Austen Quarry Stage 2 Extension Project Modification 1 (SSD 6084 MOD 1) Operational and Truck Dispatch Changes

Environmental Assessment Report Section 4.55(2) of the *Environmental Planning and Assessment Act 1979*

Figure 2: Approved and proposed quarry layout

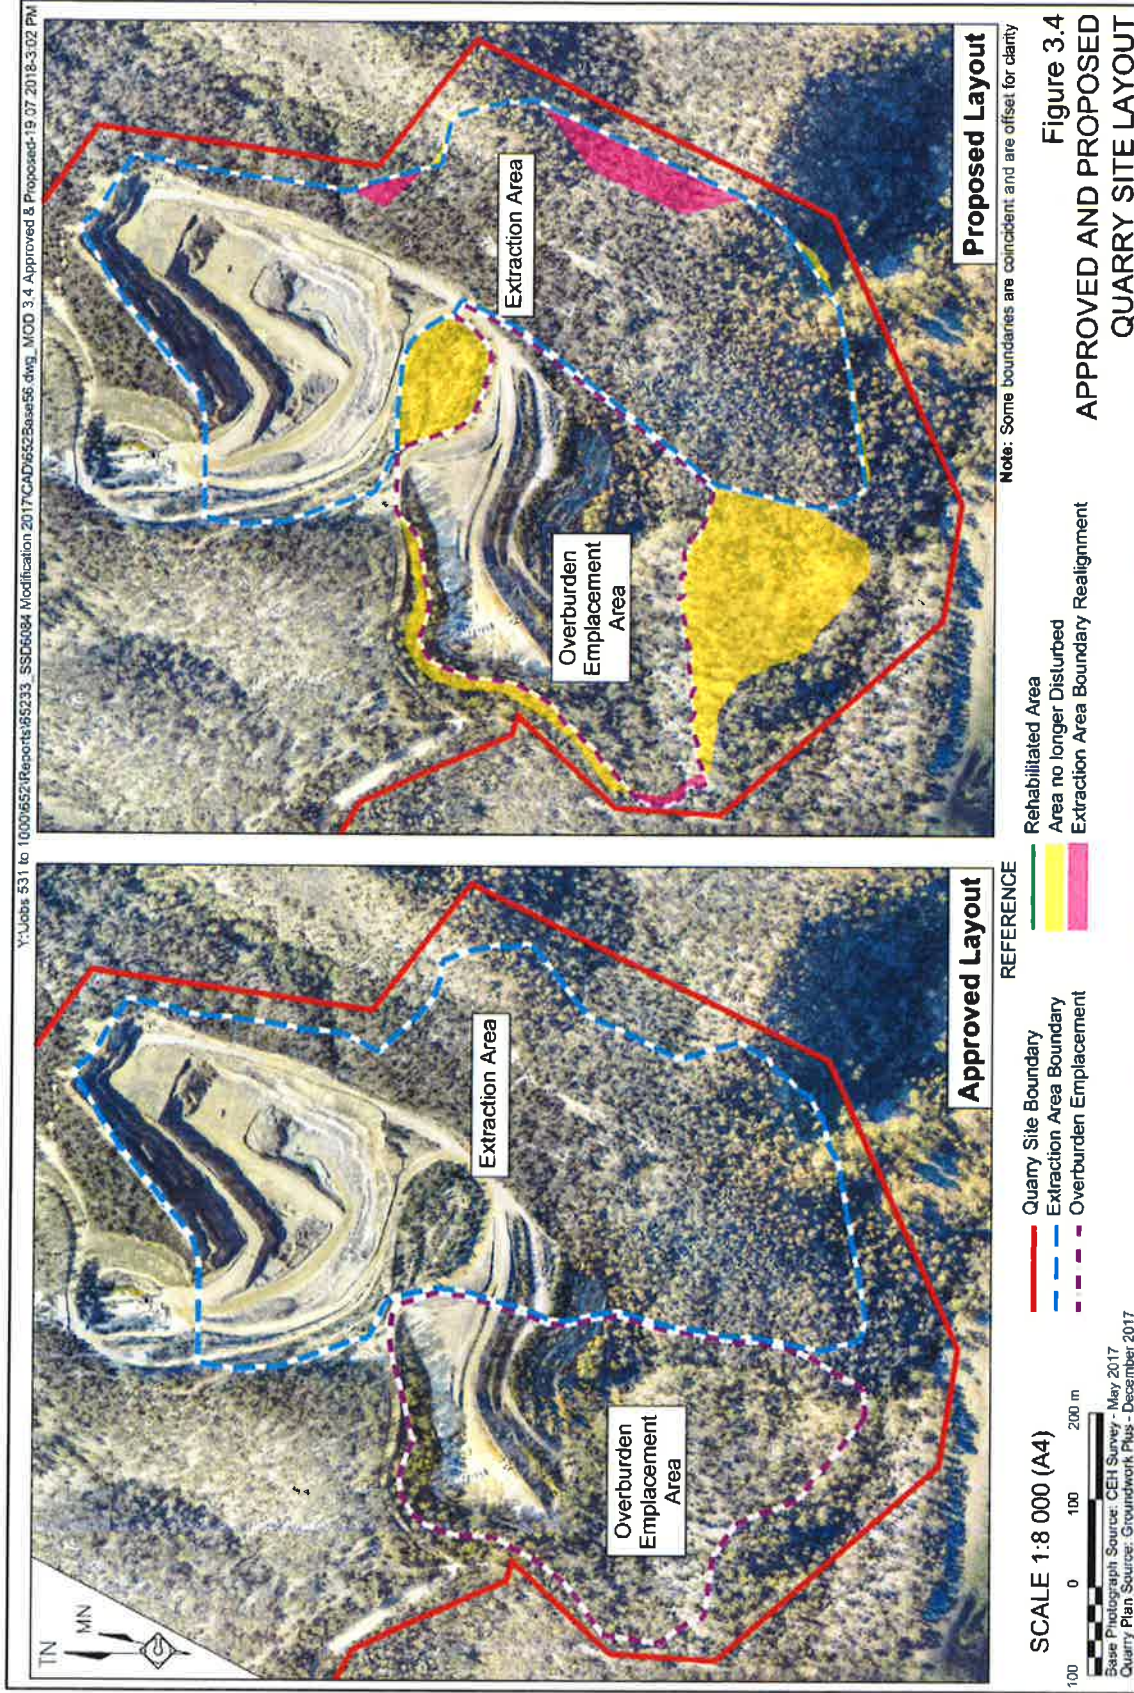
As shown in **Figure 2**, Hy-Tec proposes to realign the:

- extraction area along the western and eastern boundaries to improve worker safety in narrow areas, reducing the total extraction area from 28.2 ha to 25.2 ha; and
- overburden emplacement area by removing the southern section and extending laterally to the east (into what would formerly have been the extraction area), reducing the overburden emplacement area from 13.5 ha to 12.2 ha.

Figure 4: Predicted temperature inversion noise levels during the morning shoulder period

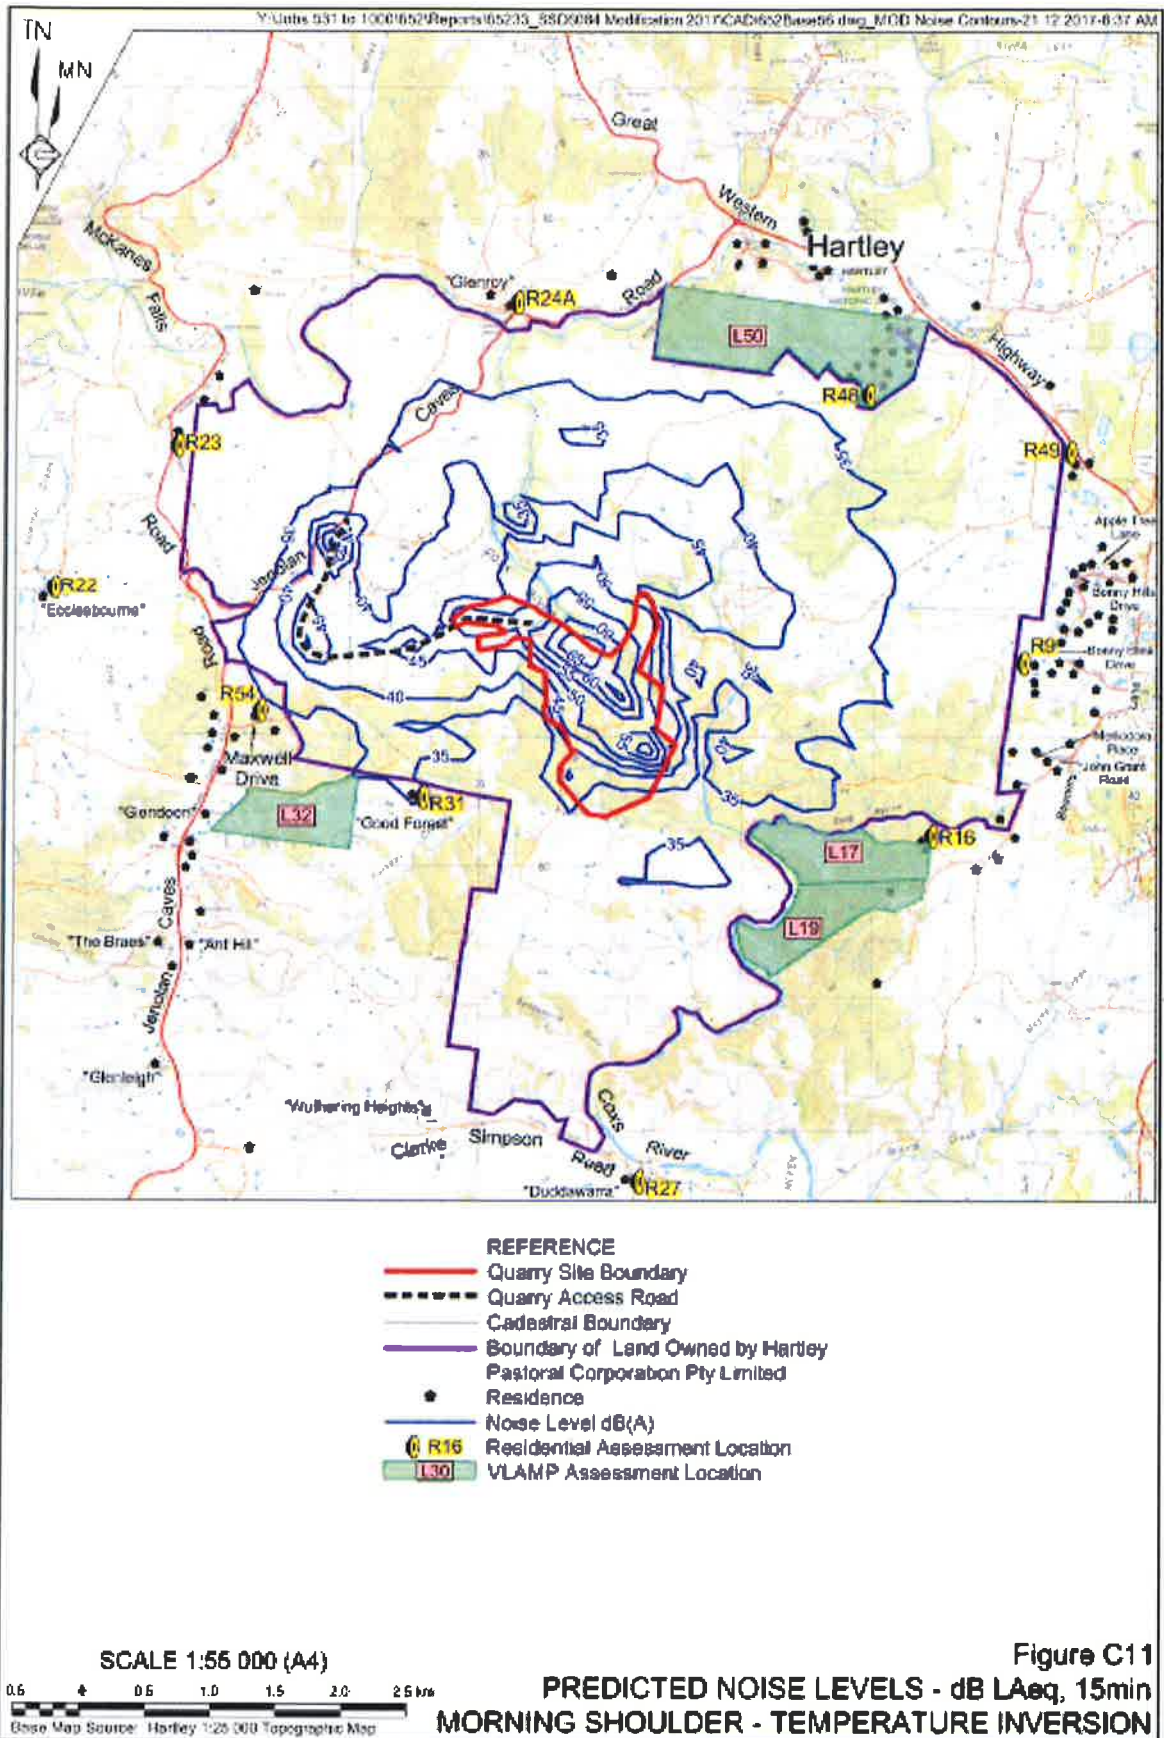
During both calm and temperature inversion conditions (which represent a worst case and occur largely during winter nights), noise emissions would not exceed either the existing noise criterion of 35 dB(A) or the new PTNLs (see **Table 3** and **Figure 4**).

The Department is satisfied that the proposed modification would not cause increased operational noise impacts at receivers above those already approved. The Department recommends the existing noise criteria are updated to include sleep disturbance noise criteria for the early morning shoulder period.

Figure 5: Proposed final landform

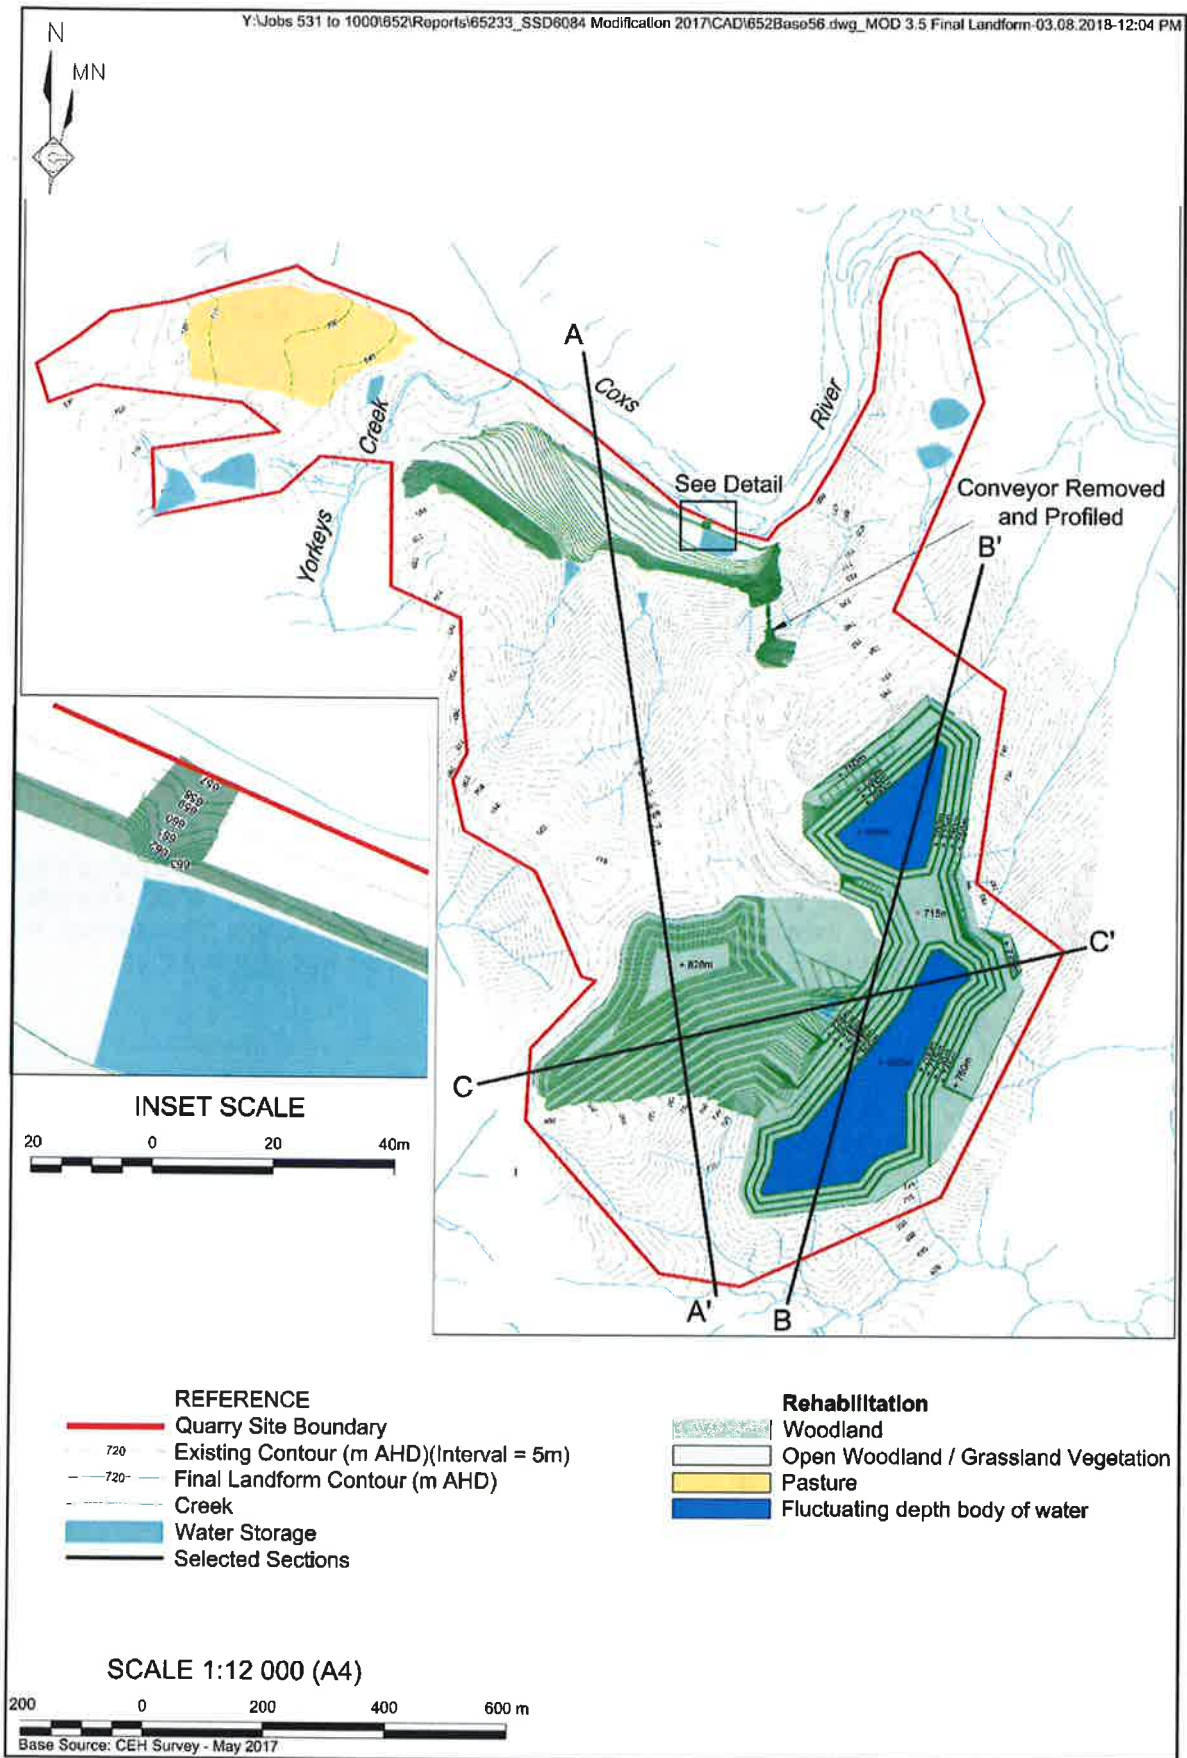
The proposed modification would result in a slightly narrower final void as a result of the realignment (see **Figure 5** and **6**). Hy-Tec considers that the proposed final void would not require different erosion

<ul style="list-style-type: none"> Hy-Tec considers the long-term visual impact of the terminal quarry faces would be progressively reduced by the establishment of vegetation on the final benches (see Figure 5). Hy-Tec also considers the realigned extraction area and overburden emplacement area would not result in significant changes to the outlook from nearby vantage points. The existing Landscape and Rehabilitation Management Plan requires that vegetation screens are established to minimise visual impacts, and that the effectiveness of these measures are monitored. The Department notes that recent (May 2018) planting of native seedlings on the northern ridge, overburden site and quarry highwall would eventually provide visual screening. 	
<i>Social and Economic Impacts</i>	<ul style="list-style-type: none"> The proposed modification would result in employment of an additional 15 full-time transport contractors. The majority of these contractors live close by and therefore some employment benefits would be experienced locally. Hy-Tec notes potential for an additional nine quarry employees, based on delivery timing and customer demand. The increased despatch limit would also increase annual contributions paid to LCC. 	<ul style="list-style-type: none"> The Department acknowledges the significant mitigation measures undertaken by Hy-Tec to address the amenity issues raised by R24A. The Department is satisfied that there would be negligible adverse social impacts resulting from the proposed modification and considers there is likely to be local benefit from increased employment.

The Department notes that these objectives are consistent with existing conditions of consent and the changes would reduce the overall area to be rehabilitated. The Department is satisfied that the final landform and rehabilitation would not result in any additional impacts above those already approved. Existing conditions of consent require Hy-Tec to develop and implement a Landscape and Rehabilitation Management Plan. The Department recommends that Hy-Tec update the Landscape and Rehabilitation Management Plan to reflect the proposed modification.

Figure 6: Cross-sections of proposed final landform

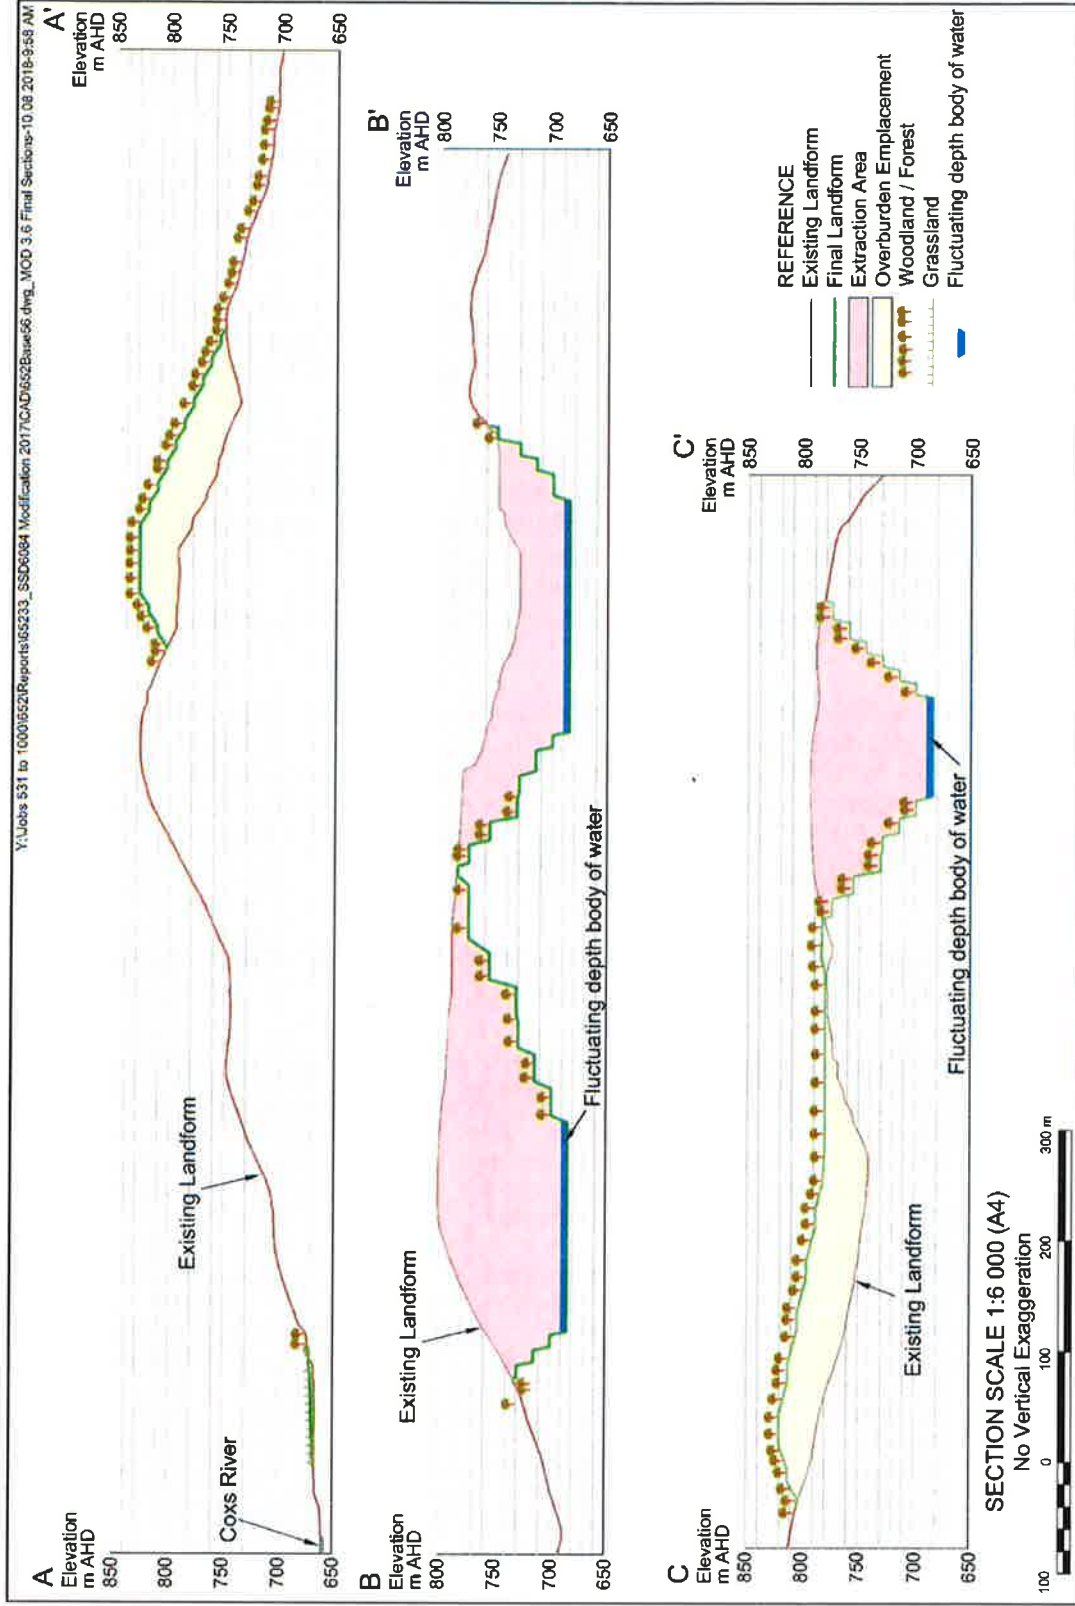
The modification would also change the approved final overburden emplacement area with a proposed elevation of approximately 830m AHD, approximately 20 m higher than that currently approved (see **Figure 6**). Hy-Tec considers this elevation is consistent with the nearby ridge and therefore would effectively blend in with the surrounding landscape.

Visual	<ul style="list-style-type: none"> The proposed changes to the overburden emplacement area would result in an elevation of approximately 830m AHD, which is 20 m higher than currently approved (810m AHD). Hy-Tec notes that this higher elevation would be consistent with the nearby ridge and would effectively blend with the surrounding landscape. As discussed in Section 4, BMCC, noted that proposed road workson the Great Western Highway between Mount Victoria and Katoomba, will involve removal of trees which currently provide screening of the quarry. Hy-Tec noted that while this is not related to the modification it would discuss providing BMCC with a contribution towards its replanting costs. 	<ul style="list-style-type: none"> The Department is satisfied that visual impacts of the proposed modification would be negligible. The Department considers that existing conditions would continue to adequately manage potential visual impacts and recommends that the Landscape and Rehabilitation Management Plan is updated to reflect the modification.
